From: Terry Ashton [/O=BODYCOTE/OU=EXCHANGE ADMINISTRATIVE GROUP (FYDIBOHF23SPDLT)/CN=RECIPIENTS/CN=TERRY.ASHTON]
Sent: 07/11/2013 09:50:37
To: Tomas Rek [tomas@studioe.co.uk]
CC: Bruce Sounes [bruce@studioe.co.uk]; Paddy Glennon [paddy@studioe.co.uk]
Subject: RE: Grenfell - Fire Strategy comments
Attachments: Grenfell - AOV scheme.pdf

Fire protection of steel structures

1. Separating wall

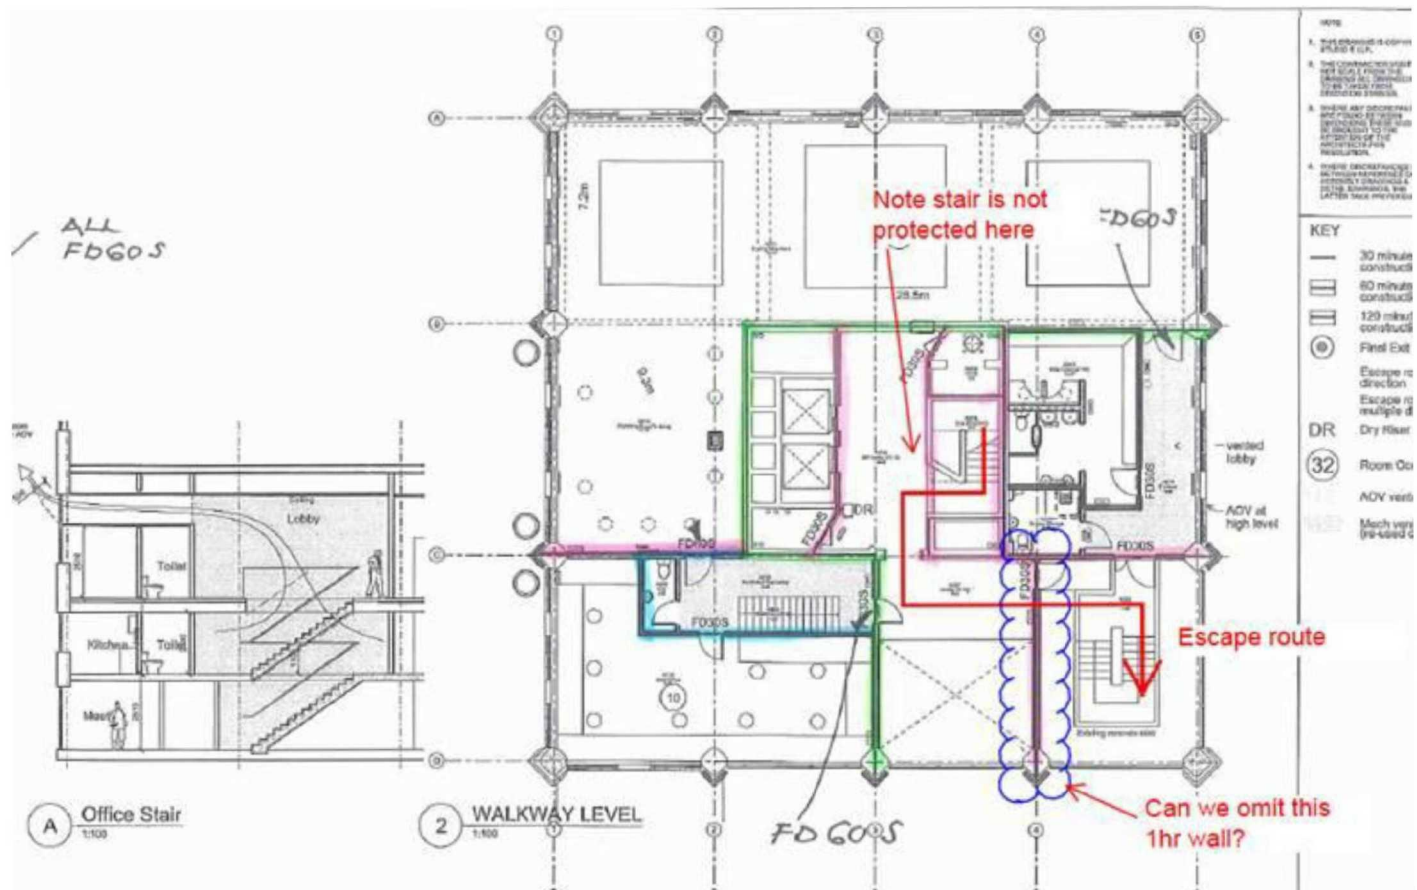
We don't like the separating wall between stair and lobby. There is a need to maintain a separation for security but it would be preferable if this was just a low screen and door at each level. The concierge would have a good view of what's going on.

I don't understand the need for the 60 minute separation because you have to pass through the (sterile) entrance lobby to get to the stair anyway. If there is an issue of smoke we could put an AOV on the façade.

I've re-done the compartmentation drawings showing what would be necessary if you didn't want to fire rate the screen and door between the boxing club stair and the entrance void. If you're happy with the changes, I'll amend the report and send it to you. The basis for connecting both AOVs to the stair is that the lower one will provide replacement air for the one at high level. There would be no need to have two AOVs at ground floor level unless you thought that was better architecturally. The opening between the stair and the shaft connecting to the AOV on the external façade could just be a louvred panel providing the same geometric free area as the AOV.

2. AOV

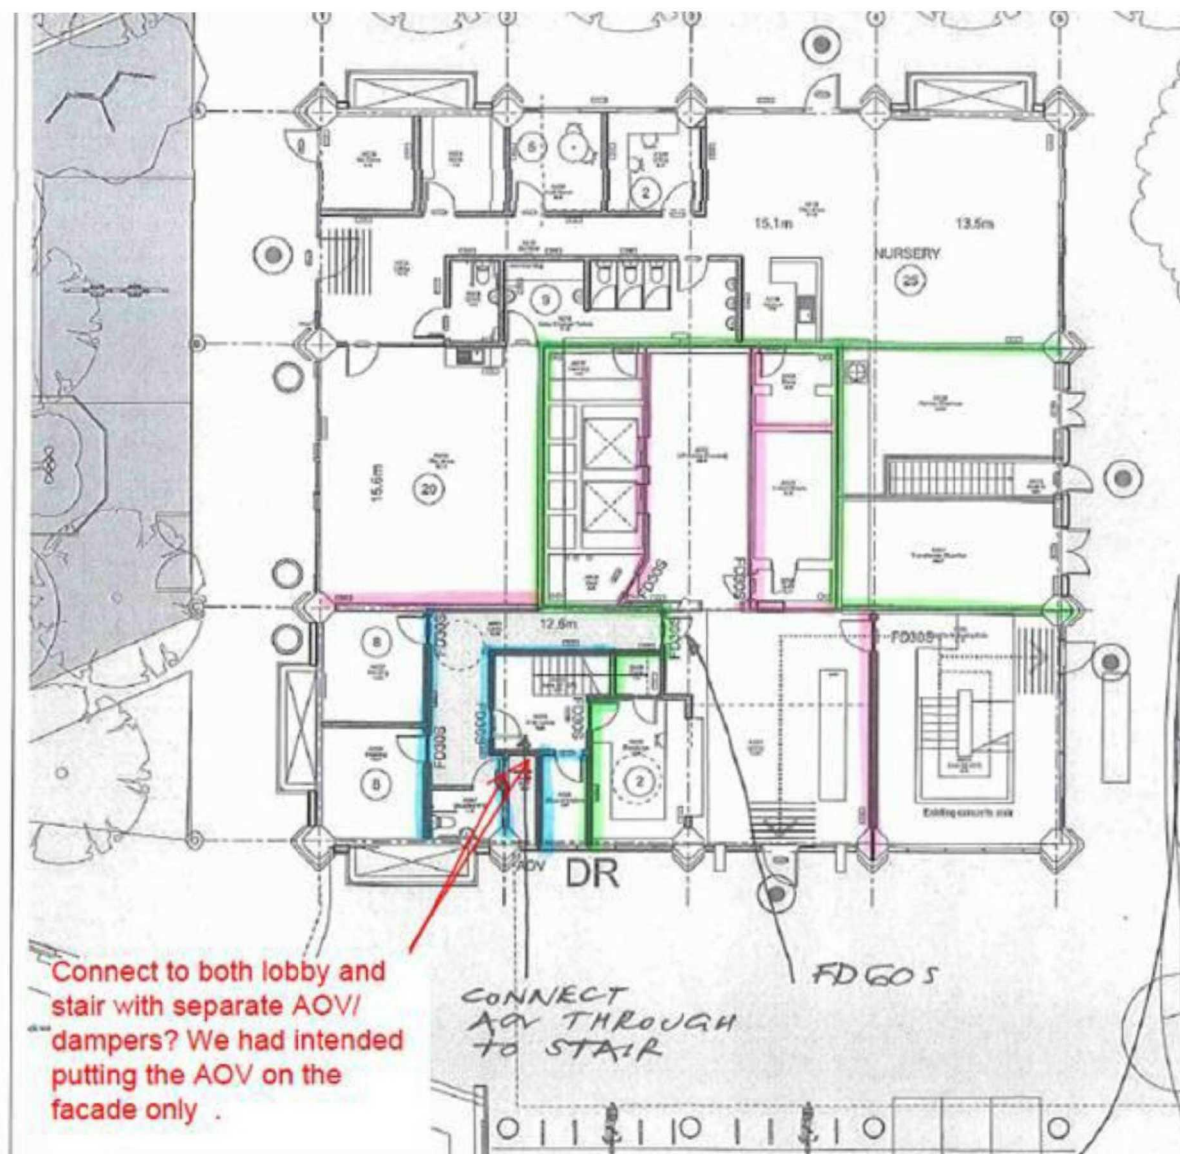
Please clarify how the AOV would operate? Would there have to be two internal AOV's and would they be fire rated and activated separately?
